SUBJECT: LANDING LIGHT REPLACEMENT

SERIALS AFFECTED: All Model AA-1 and AA-1A, AA1B-0001 thru AA1B-0550,  
and AA5-0001 thru AA5-0640

TIME OF COMPLIANCE: Each time landing light is replaced.

Figure 1: All Model AA-1 and AA-1A;  
AA1B-0001 thru AA1B-0338;  
AA1B-0340; AA1B-0343;  
AA1B-0346 thru AA1B-0370;  
AA5-0001 thru AA5-0640.

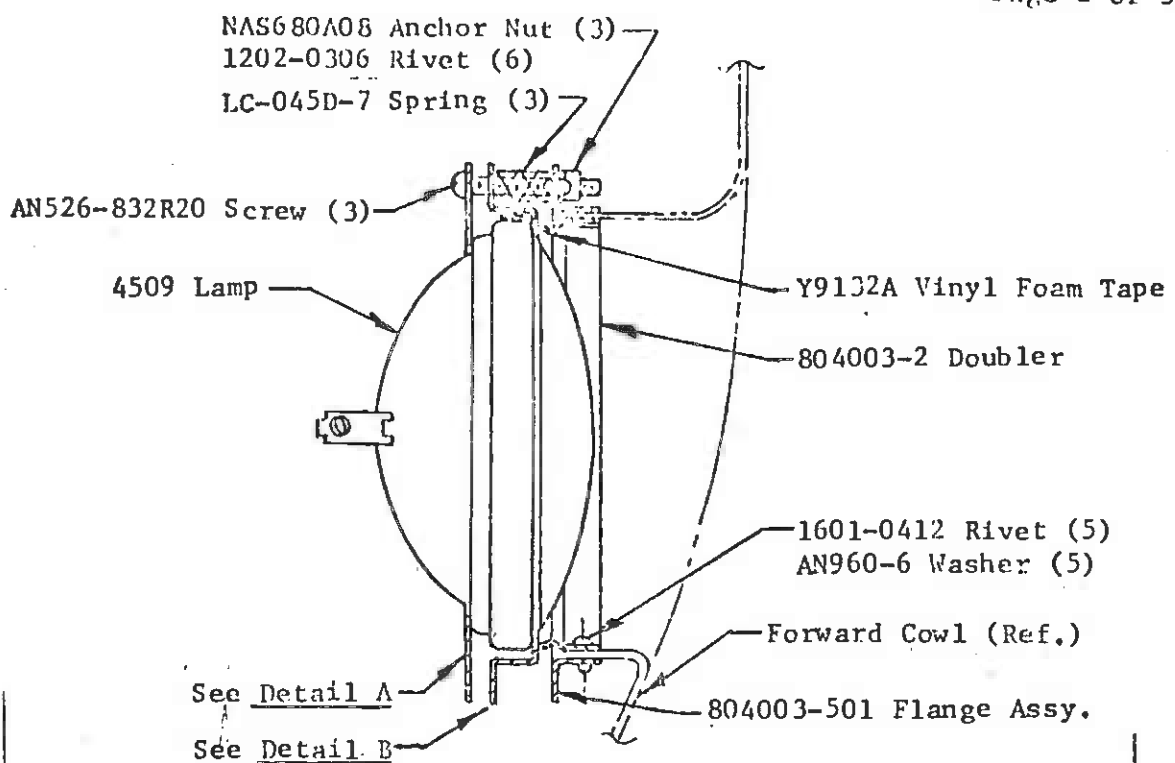
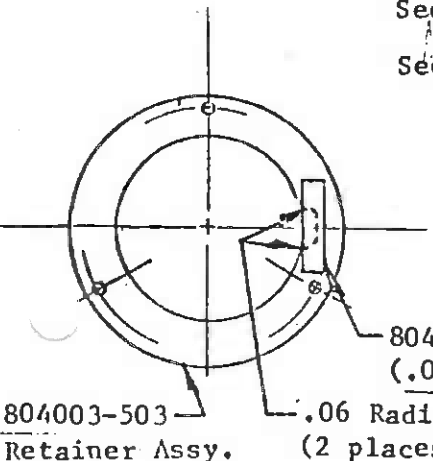
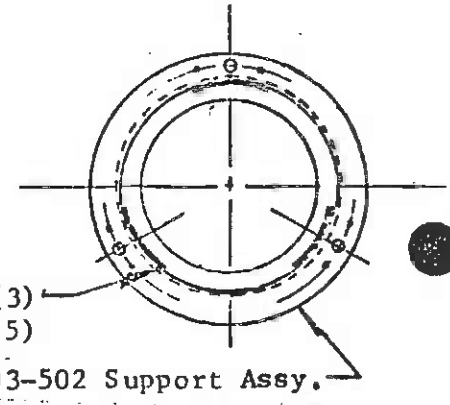
1. From behind the forward cowl, remove existing lamp and inspect retainer, support and flange assemblies for cracks; screws and anchor nuts for type specified and thread condition; and tapes for deterioration. Replace all items that are worn or damaged.

2. View the intersection of the locating notch and the inside diameter of the 804003-503 Retainer Assembly shown in Detail A. If a sharp corner exists, round off to .06 inch radius.

3. If 804003-5 & -6 Tapes were not provided as original equipment, fabricate tapes out of .06 inch thick vinyl foam tape (single faced) and attach as shown in Details A and B.

4. Subassemble retainer, lamp, support, screws and springs, and loosely attach to forward cowl. Adjust light to lowest position possible by tightening top adjustment screw fully and lower two screws only enough to eliminate gap between lamp and cowl.

5. Refer to applicable Service Manual for final adjustment specifications.

Figure 2: AA1B-0339; AA1B-0341;  
AA1B-0342; AA1B-0344;  
AA1B-0345; AA1B-0371  
thru AA1B-0550.

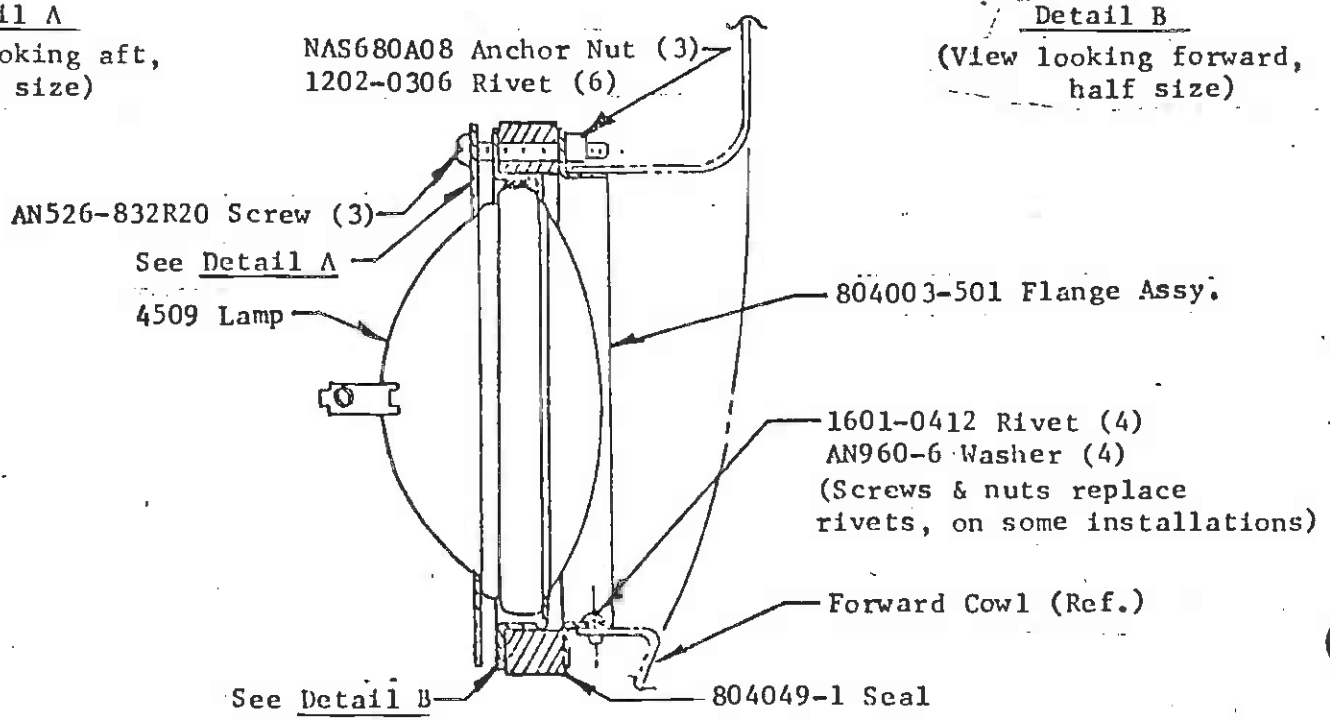
1. From behind the forward cowl, remove existing lamp and inspect retainer, support and flange assemblies for cracks; screws and anchor nuts for type specified and thread condition; and seal and tapes for deterioration. Replace all items that are worn or damaged.

2. View the intersection of the locating notch and the inside diameter of the 804003-503 Retainer Assembly shown in Detail A. If a sharp corner exists, round off to .06 inch radius.

3. If 804003-5 & -6 Tapes were not provided as original equipment, fabricate tapes out of .06 inch thick vinyl foam tape (single faced) and attach as shown in Details A and B.

4. Cement 804049-1 Seal to 804003-502 Support Assembly, if not joined on original installation. Contact Cement 2210, 3-M Company, is an approved adhesive.

5. Subassemble retainer, lamp, support/seal assembly and screws, and loosely attach to forward cowl. Tighten screws until seal is compressed to  $.68 \pm .10$  prior to landing light adjustment.

6. Refer to applicable Service Manual for final adjustment specifications. Do not compress seal to less than .50 inch thick.
